RE: RAWP Addendum/Response to Department Comments Letter (October 1, 2025)  
Rhode Island Recycled Metals  
434 Allen's Avenue  
Providence, Rhode Island  
Plat Map 47 / Lot 601 & Plat Map 55, Lot 10  
RIDEM File No. SR-28-0143

This correspondence is provided as the Remedial Action Work Plan (RAWP) Addendum requested in the Department's October 1, 2025 comments regarding the Rhode Island Recycled Metals RIRM prepared by Lake Shore Environmental (LSE) and dated August 13, 2025. Department comments shown below are in italics.

DRAWINGNO:	FIGURE 2	REV.:	A
------------	----------	-------	---

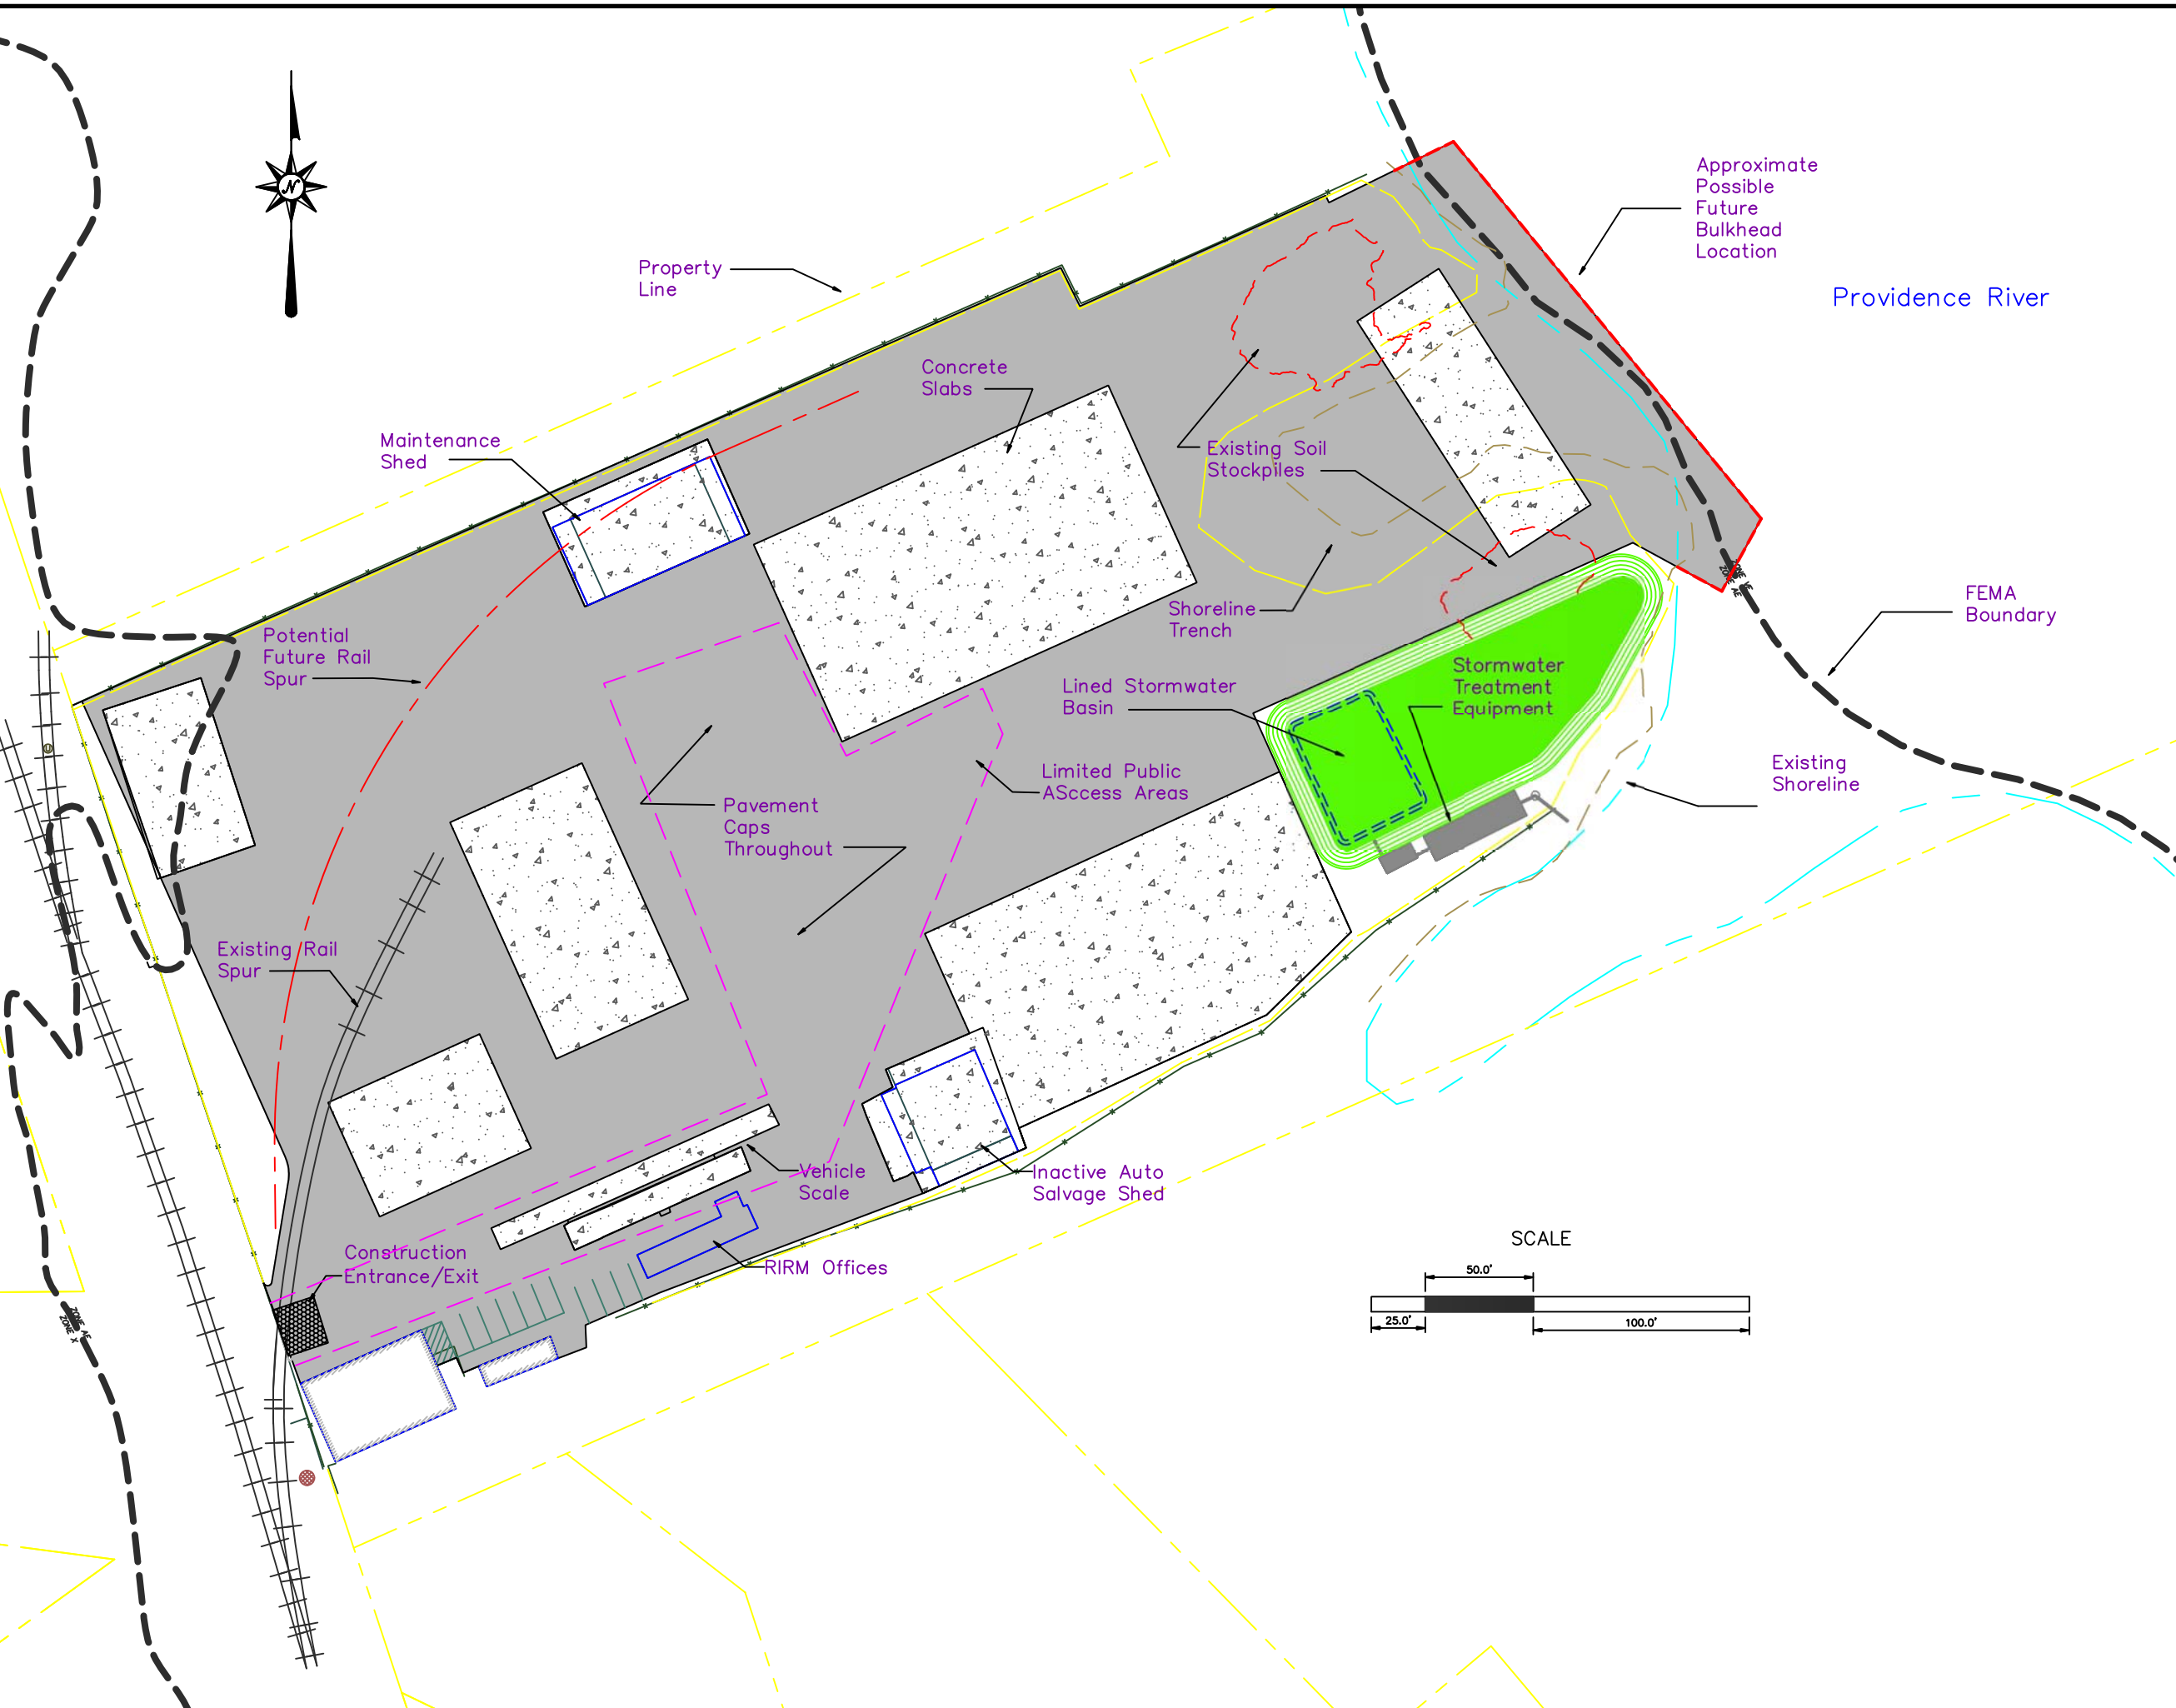
- a. *Please submit Site Figures that are drawn-to-scale, and, at a minimum, contain a scale, a north arrow, property lines, and a populated legend.*
- b. *Please provide one or more site plans that depicts all current and existing site features and details such as lot lines, property entrances & exits, ground surface type, defines all structures and their primary use(s), scrap piles and contents, hazardous materials storage and handling areas, loading and unloading areas, locations of air monitoring, details regarding the bulkhead, soil piles, vehicle decontamination stations, etc.*

- d. *Please specify on the site plans any areas that will be accessible to customers or the public.*

Understood. An updated site plan depicting the current and existing features, drawn-to-scale with a scale, north arrow, property lines, and populated legend is included as [Figure 2](#). An additional site plan depicting planned post-remediation conditions, drawn-to-scale with a north arrow, property lines, and a populated legend is included as [Figure 3](#). Areas accessible to the public both currently and in the post-remediation plan are depicted in both figures.

DRAWINGNO:	FIGURE 3	REV.:	A
------------	----------	-------	---

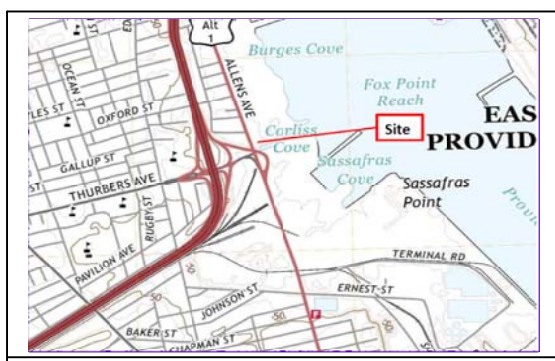
- c. *Please provide one or more site plans, drawn-to-scale, that depicts the locations of all post-remediation site features including, structures, caps and specification, specific operation areas, scrap piles and contents, hazardous materials storage and handling areas, loading and unloading areas, crushing machinery, vehicle traffic pattern, where specific sorting operations take place, vehicle scale, decontamination stations, trackout emissions prevention, barriers of any type, etc.*

### **COMMENT #9A – CAP SPECIFICATIONS**

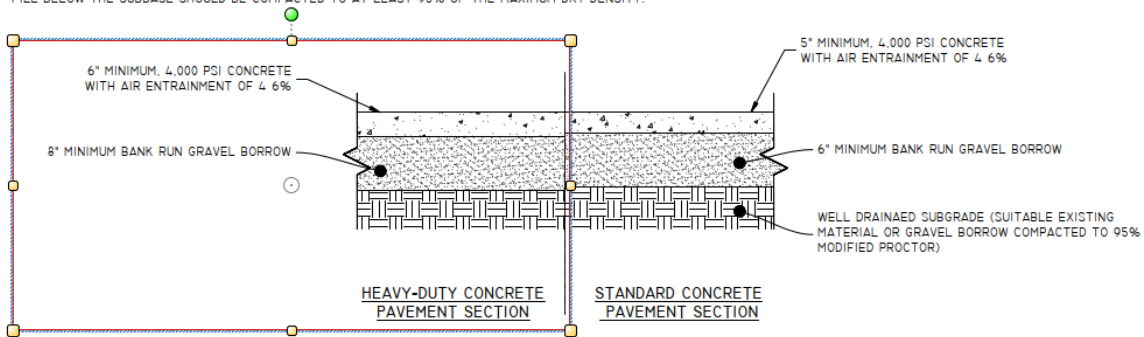
- a. *In accordance with § 1.10.10 of the Remediation Regulations and as required by the Remedial Decision Letter, please provide specifications for each cap design which shall include materials, construction specification, and drawings for each, stamped and signed by the Profession Engineer responsible for the design.*

Cap specifications in the form of cross sections are included as Attachment C. Further details regarding the cap designs will be provided by DiPrete Engineering as part of stormwater permit submittals and will be stamped by a licensed P.E. when they become available.
